BZA
Case No. 17127
Exhibit No. 2

Board of Zoning Adjustment
District of Columbia
CASE NO. 17127
EXHIBIT NO. 2

ZONING REGULATION VIOLATIONS ALLEGED IN THE APPEAL

DRAWN NIN | DATE: 08/14/0
SCALE AS NOTED
DWG NO
M-6005828-020

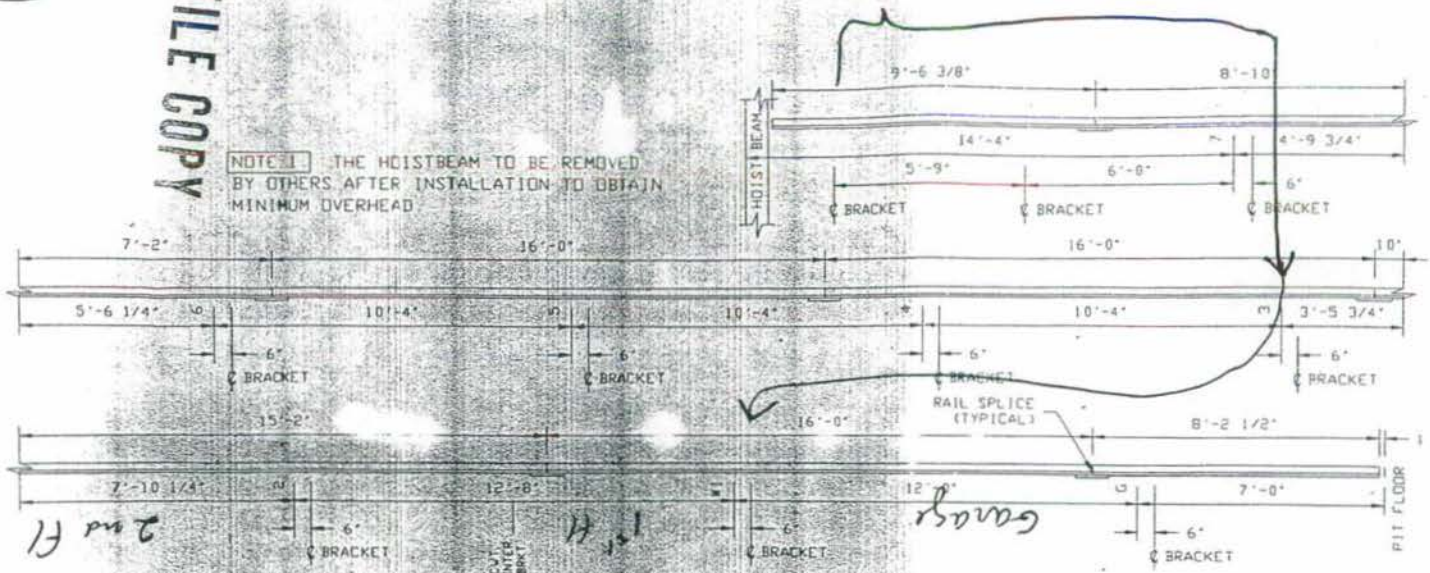
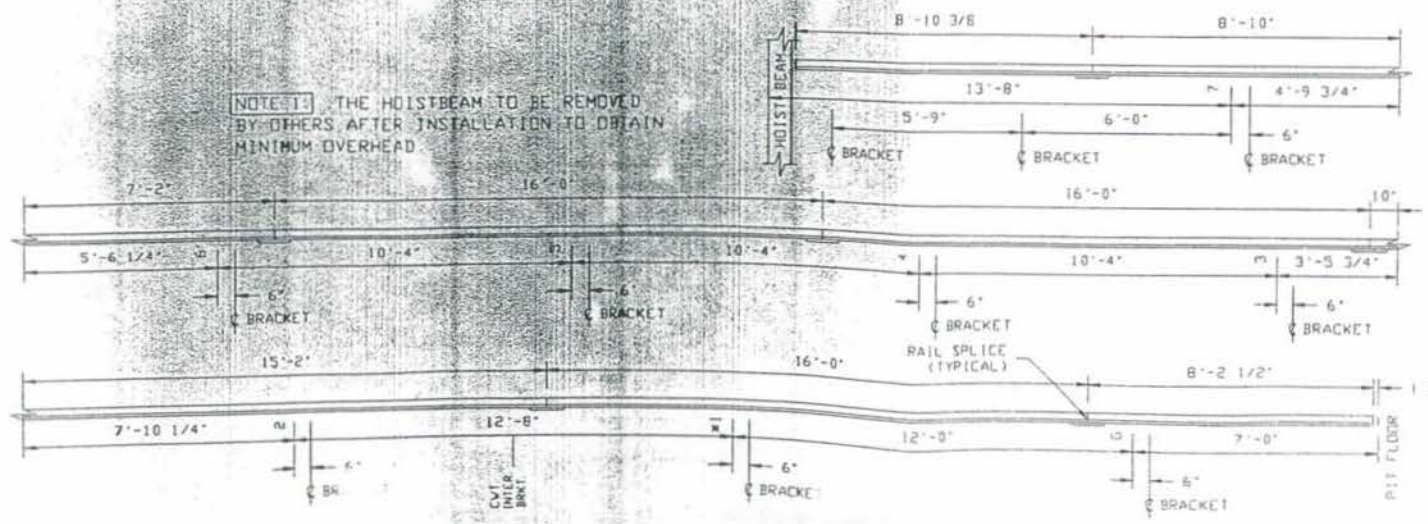
1st-7th flrs: 75.67 (#B453159, DWG No. M-6005828-0, SHEET 3 -- p.16)
Main Roof : 15.00 (#B454315 Sheet A108, J14 TYP. ROOF TRUSS SECTIONS, p.

Accurately shows height of the building from first floor to horizontal roof over the 7th floor–75.67 ft. Combined with 15 ft. roof and additional height between curb and first floor, the building exceeds 92 feet.

WALL TEST REPORT

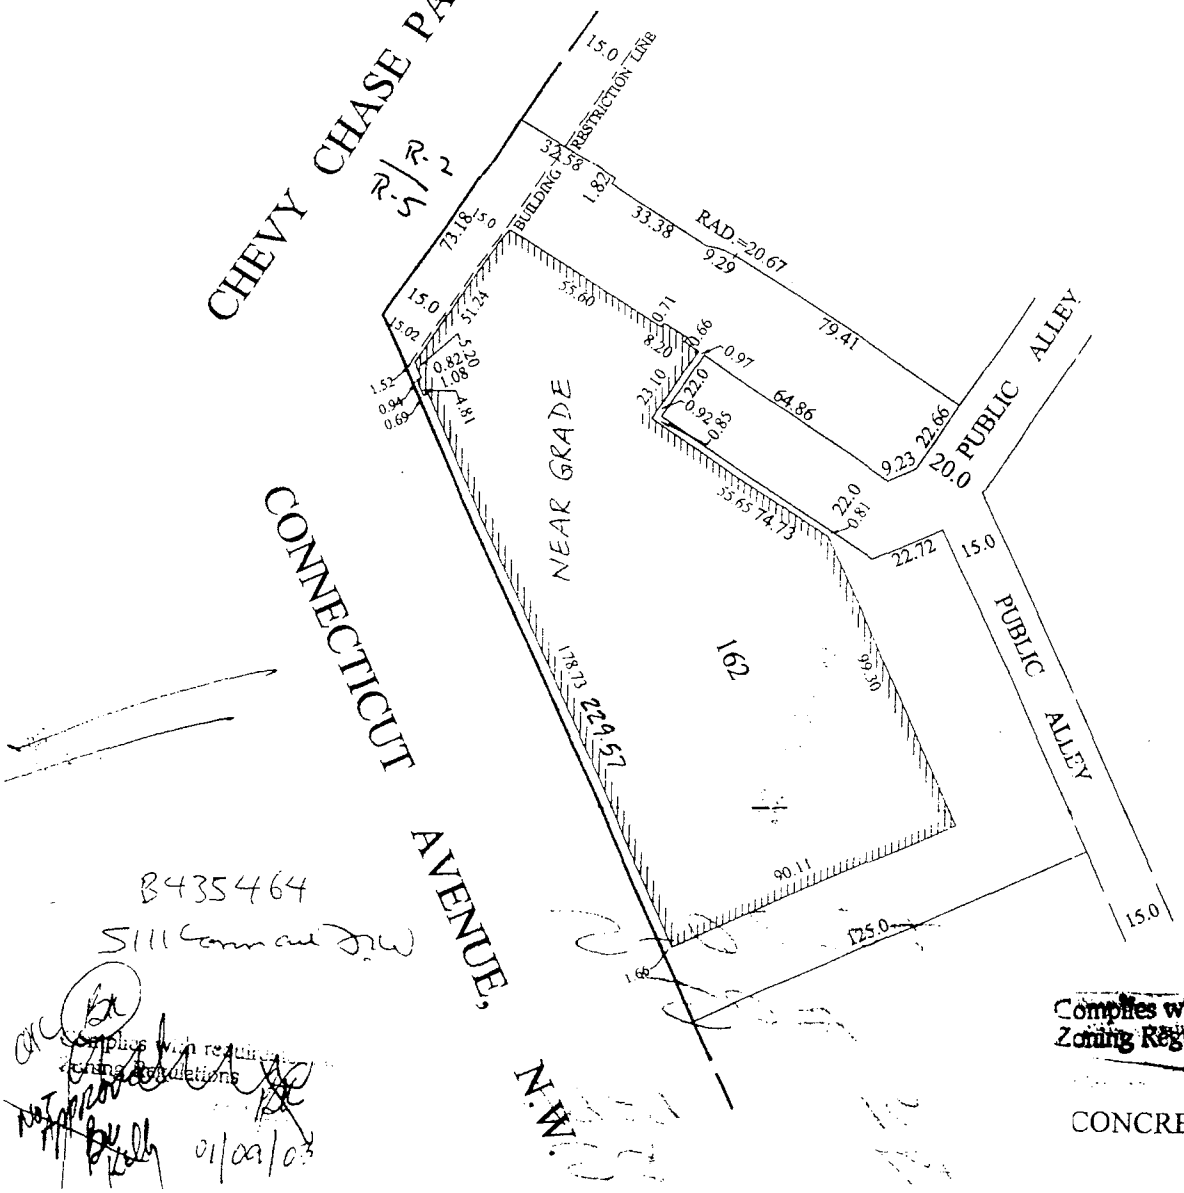
17 Wall Test Report – (Garage level), dated 1-27-03
Building garage-level footprint extends into R-2 District ~ 1 ft.

Building footprint crosses R-2 District line.

Drawing Title: FIRST FLOOR PLAN

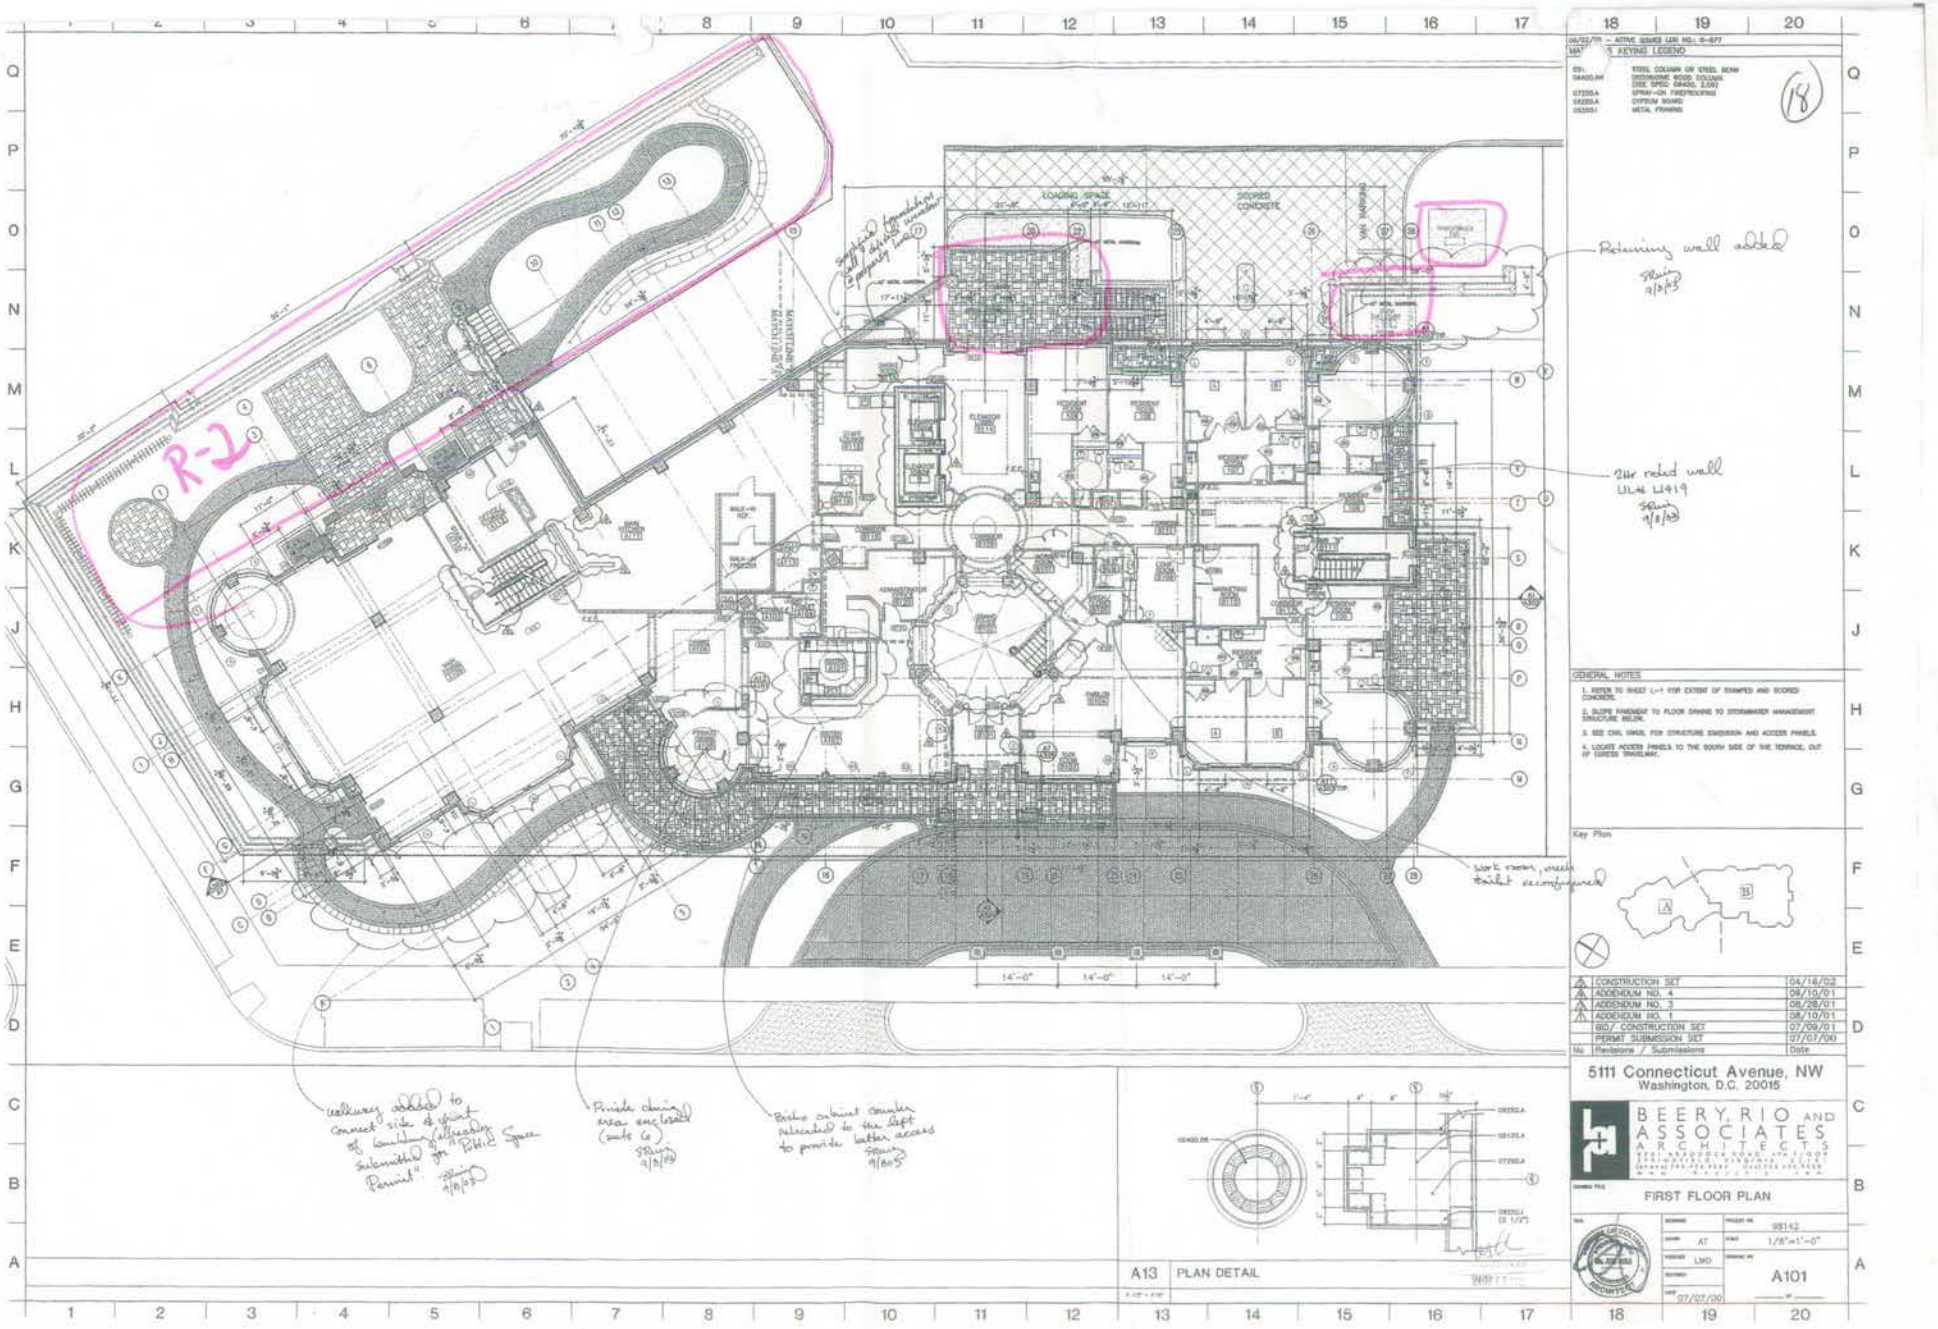
18 Revised 1st Floor Plan
Premises of facility in R-2 District includes a required means of egress, handicapped ramp, kitchen delivery, and resident garden.

GRADING PLAN

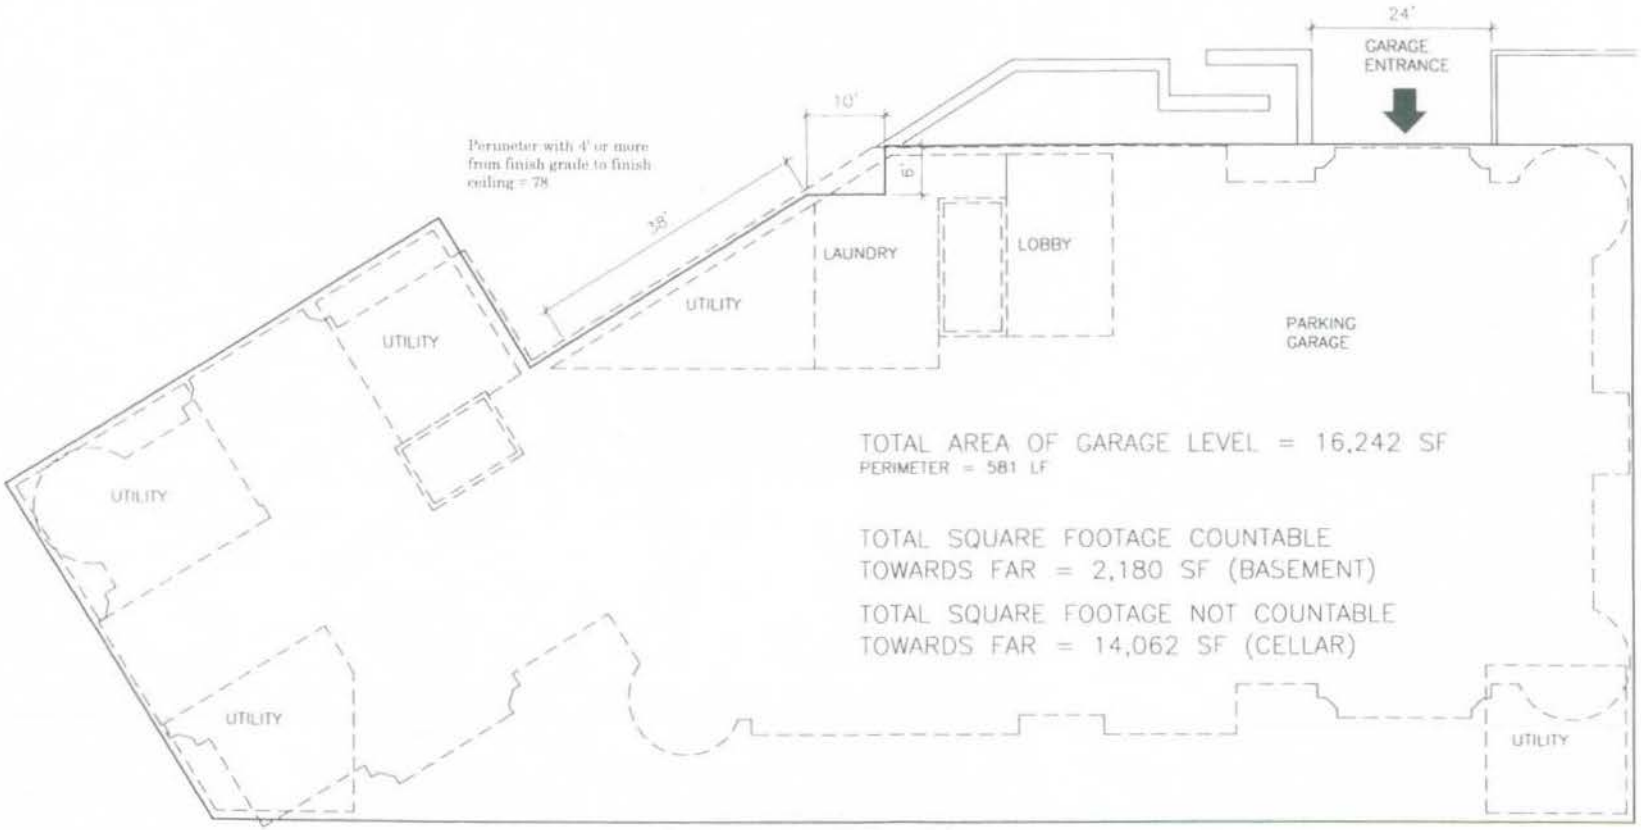
The additions to the building at the garage level (revised Garage Plan, p. 6) bring the FAR over 3.5 allowed in an R-5-D District or 1.8 in an R-5-B District. In addition, the change in grade adjacent to these additions (lowered compared to original plans, see Grading Plan, p. 11) further increases FAR into noncompliance by increasing the proportion of the garage-level which is basement and decreasing cellar (using the perimeter). The original garage footprint used in the FAR calculation (p. 12) showed the garage perimeter with basement as only 78 feet of an approximate 655 foot perimeter. The new perimeter approximately doubles the feet of basement perimeter and provides additional gross floor space to the Garage-level, increasing FAR well above regulation (§402.4).

The building height is the vertical distance measured from the level of the curb opposite the middle of the front of the building to the highest point of the roof or parapet (§199.1). Street Datum: 302.50 (#B435464, GRADING PLAN, p. 11).

78 L.F. / 655 L.F. = 11.9%
16,242 SF x 0.119 = 1,933 SF

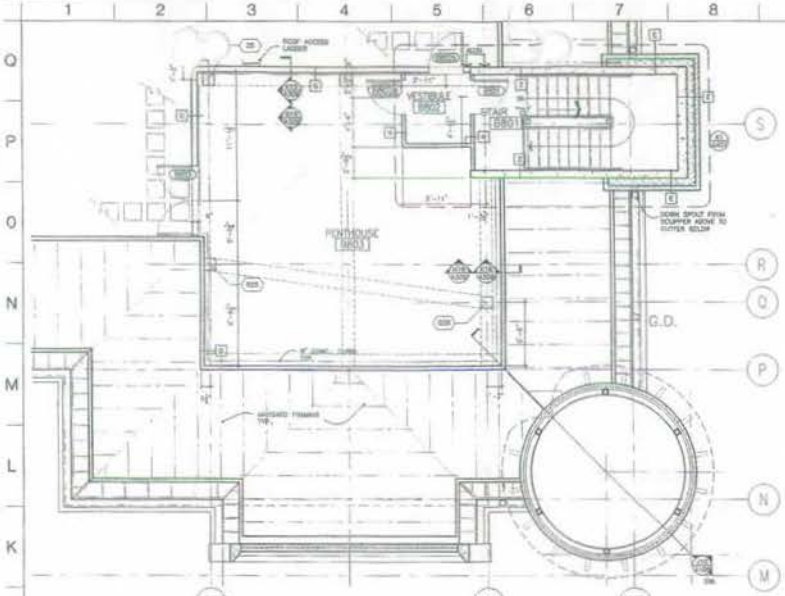
Page(s)	Item
1-4	Copies of revision permits
5	Wall Test Report, dated 1-27-03 Building extends into required rear yard, as circled
6	Revised Garage Plan, A100, (B456618, 11/7/03) Building extends into required rear yard (compare with original plan, p. 8)
7	Photo of rear building additions The rear open porch (a) and (b) room addition both extend into the required rear yard.
8	Original Garage Plan (Permit B435464) (For comparison)
9-10	Zoning Calculation Sheet – Residential District (Less than 7 sq. ft. difference between provided and allowed gross floor space in original application, Permit B435464)
11	Original Grading Plan (Permit B435464) The adjacent grade in the revisions is substantially lower than that from the original Grading Plan. (No revised Grading Plan was submitted. Lowering adjacent grade increases basement perimeter, decreases cellar, and increases Gross Floor and FAR.)
12	Garage Zoning Calculations -- square feet and perimeter For comparison, only 78 feet was caller basement perimeter in original zoning calculations.

J14 TYP. ROOF TRUSS SECTIONS

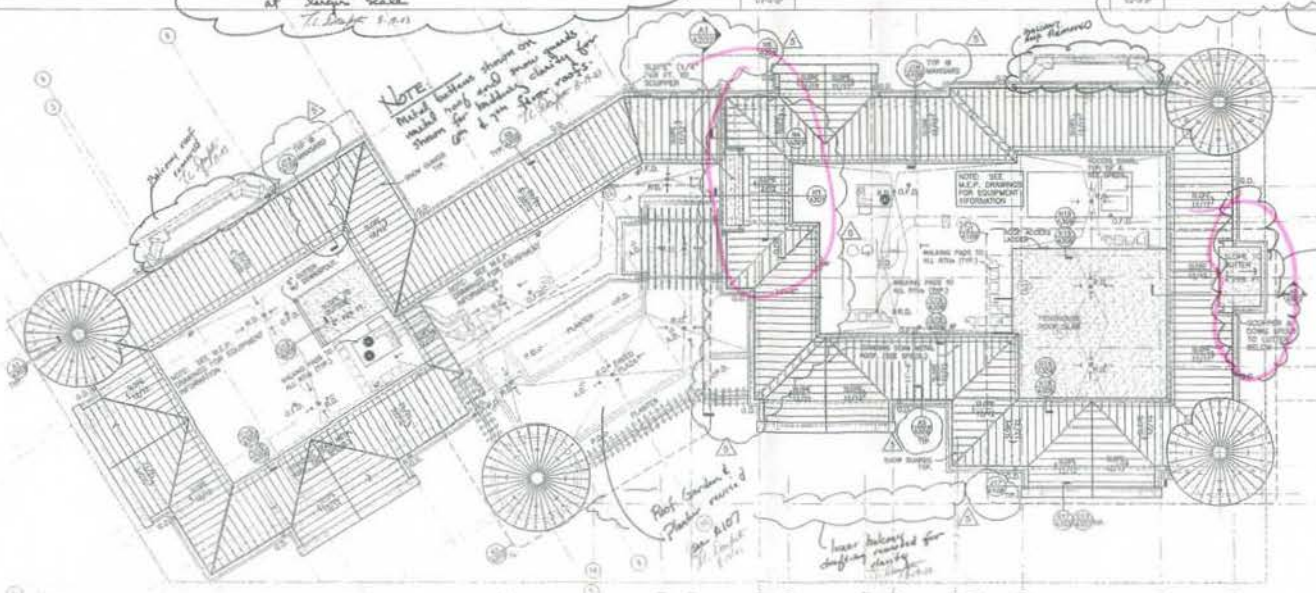
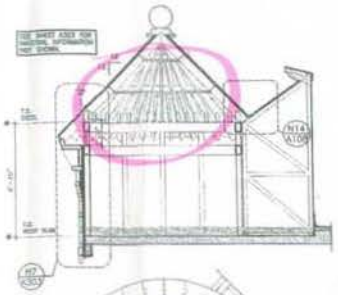
The elevator and south stairwell penthouses were revised (Roof Plan, p. 13). As both

penthouses are taller than 4 feet, they are not exempted from roof penthouse requirements. (Comparison with the previous roof plan (p. 14) shows that changes were made in the roof plan.) The south stair penthouse has no setback. The elevator penthouse is not setback by a distance equal to its total height (§411.5), which is 15 ft. above the *roof on which it sits.* The 15 ft. calculation includes the *sloped roof located on it and over it.* The two penthouses (elevator and stairwell-machine room) are separate and are incompletely surrounded and enclosed in a roof structure. This roof does not comply with requirements of a "curtain wall" (perpendicular, setback, §411.5). It is required by §411.3[4] that roof penthouses on each level be enclosed in a single structure. In addition, the revised roof plan was not submitted to the Office of Planning (§411.10).

Note that the height over 7th floor turret apartments, excluding embellishments are at least 95 (8th floor and roof, #B454315 Sheet A108, J10 (scaled) and added to 1st-7th floors; p. 13)

13	Revised Roof Plan Revisions to roof and penthouses at rear stair and elevator.
14	Previous Roof Plan For comparison.
15	Photo of front elevation of building. Showing first floor is elevated, approximately 2 ft. from curb, (not shown). These estimates are presented because Sunrise has not provided the final elevations.
16	Elevator shaft diagram
